## MODERATOR TEMPERATURE COEFFICIENT

## Safety Evaluation For A Proposed Change To The Turkey Point Units 3 and 4 Technical Specifications on Moderator Temperature Coefficient

# TURKEY POINT 3+4 MTC TECH SPEC

FIGURE 1

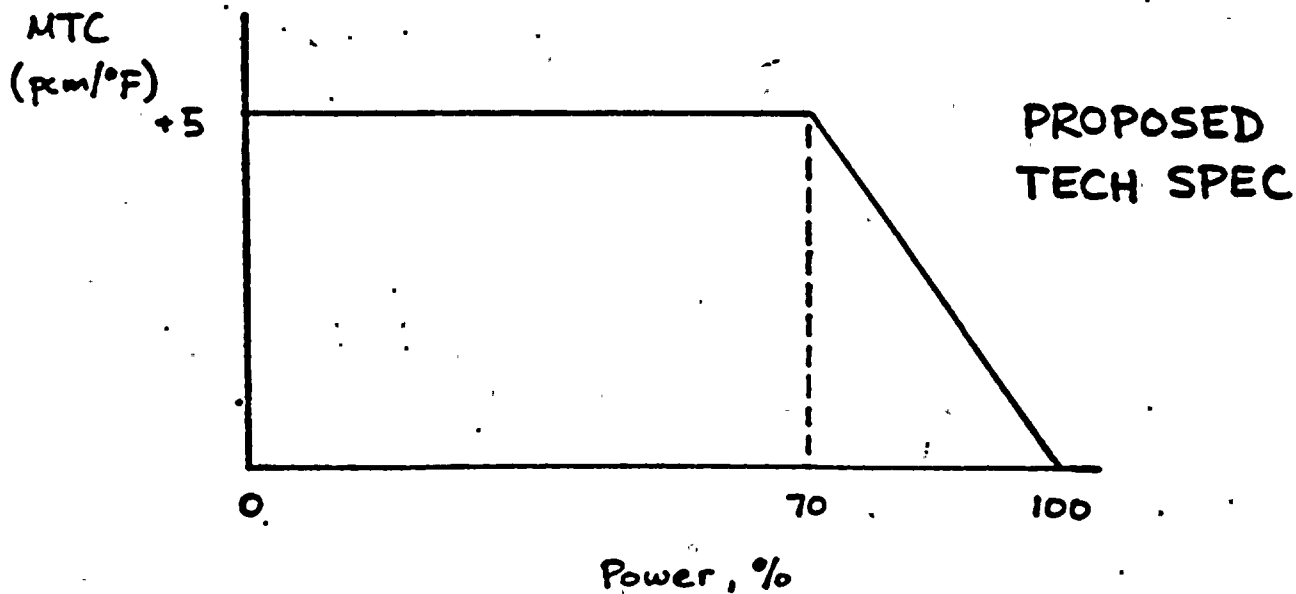
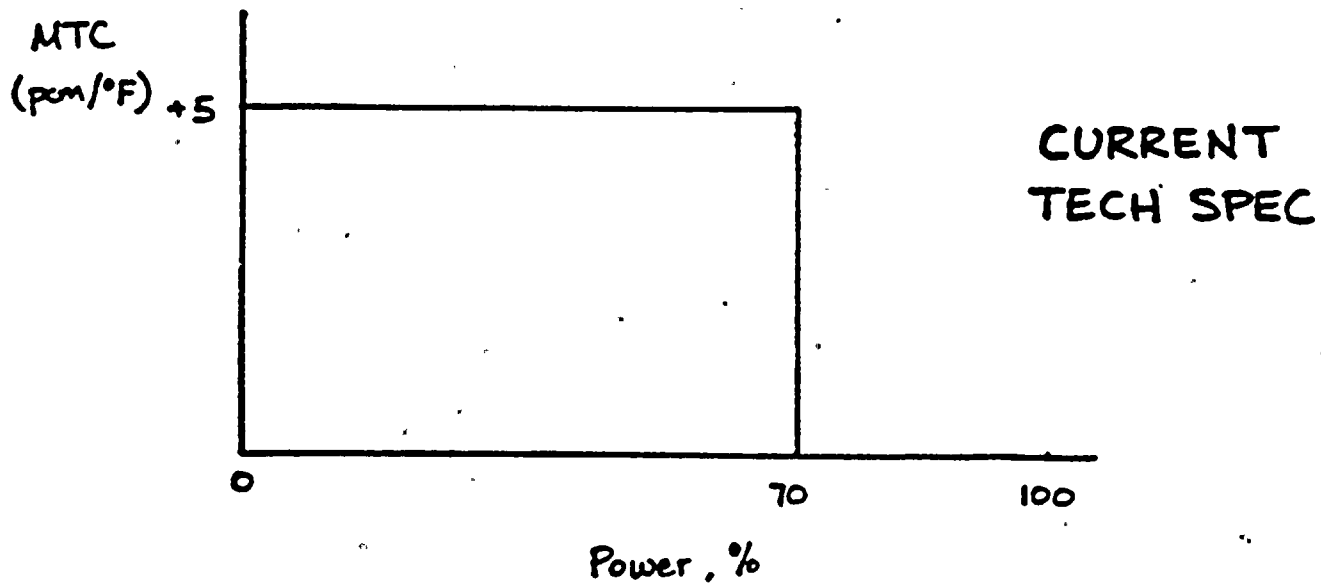
The proposed Technical Specification change substitutes a linear rampdown of the allowable MTC from +5 pcm/°F to zero between 70 percent and 100 percent rated power in place of the previous step change at 70 percent power. This is diagrammed in Figure 1. The corrective action to restore the MTC to within limits conforms to the Standard Technical Specification for Westinghouse plants.

Based on the above, it is determined that the rampdown of the allowable MTC from +5 pcm/°F to 0 pcm/°F between 70 percent and 100 percent power is bounded by the safety analysis, and is therefore acceptable.
